**BOARD OF ZONING ADJUSTMENT
STAFF REPORT**

5708/5685

6225 Rangeline Road
(East side of Rangeline Road, 1400'± North of Old Rangeline Road).

PARKING SURFACE: Parking Surface Variance to allow a disposal and recycling facility with gravel parking and maneuvering area in a B-5, Office-Distribution District.

SITE PLAN

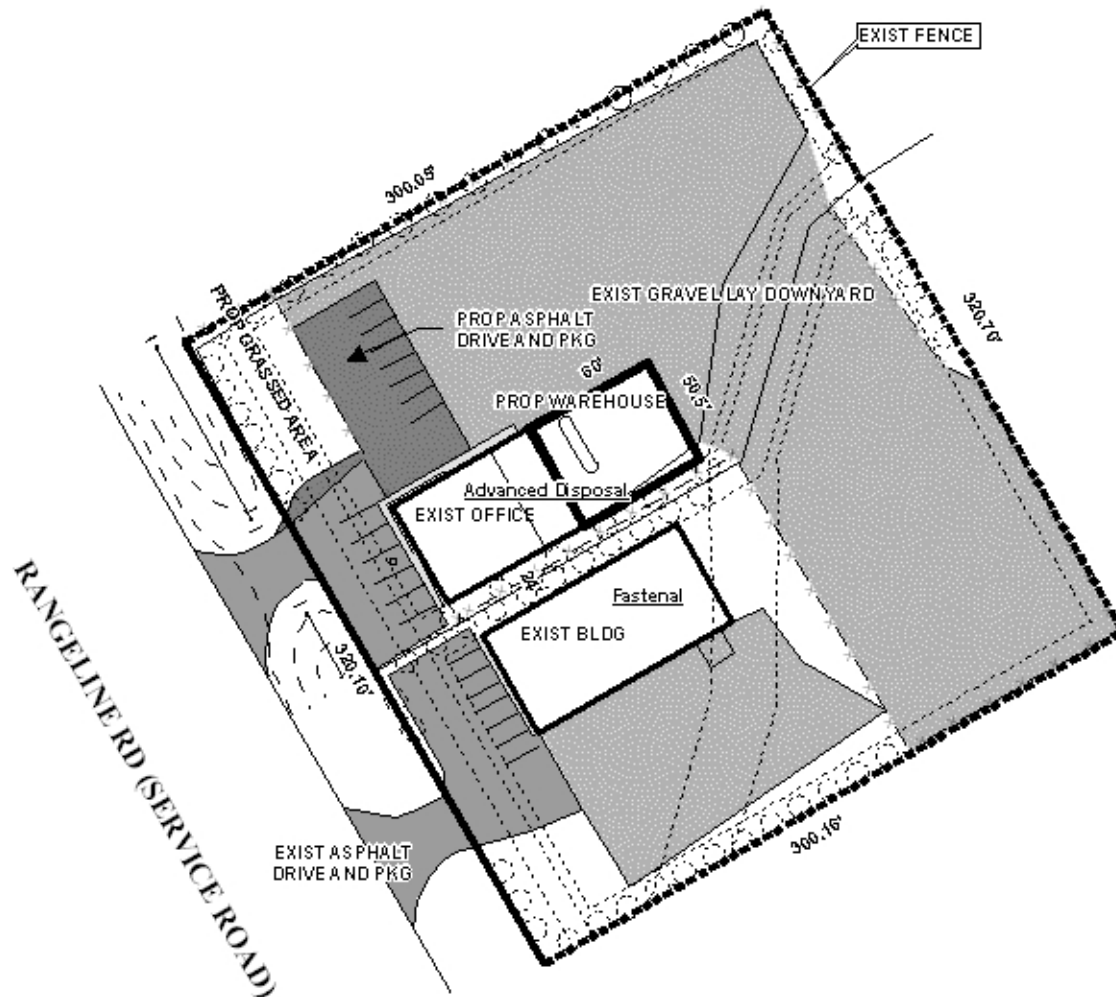
The northern most parking stall needs a slip to allow the motorist room to back out and exit the parking lot headlights first. If any work will be done in the roadway or any activities performed that will affect traffic, a Traffic Control Plan must be submitted at least two working days prior to proceeding.

The applicant states that the gravel parking/laydown area is used to park dumpster trucks and dumpsters and was on site at the time of annexation. However, the 2010 land use aerial photographs do not indicate any gravel surfacing in the area of the proposed off-site parking at 6235 Rangeline Road, and the site plan indicates existing gravel within that area. Also indicated

on the site plan and seen on recent site photographs is an un-permitted fence around the expanded gravel parking compound. The applicant was granted a sidewalk waiver for 6225 Rangeline Road at the July 7th Commission meeting.

The site plan submitted indicates seven additional proposed standard vehicle parking spaces on the applicant's site which would meet the minimum parking required for the site. There is sufficient area between the proposed new parking and the front of the property to provide at least as many more parking spaces with compliant access/maneuvering area and would allow the existing noncompliant access/maneuvering parking area directly in front of the building to be replaced with landscaped area. Therefore, the site does not impose a hardship which would prevent compliant standard vehicle parking to be provided.

RECOMMENDATION: Based on the preceding, the request for a Parking Surface Variance for the dumpster storage and loading/unloading area is recommended for approval, subject to the following condition:

- 1) the applicant is to obtain Planned Unit Development Approval for shared access and parking between the two sites.

The requests for a Parking Surface Variance for the dumpster truck parking area, the Off-Site Parking Variance, the Access/Maneuvering Variance, and the Frontage Landscaping Area are recommended for denial.
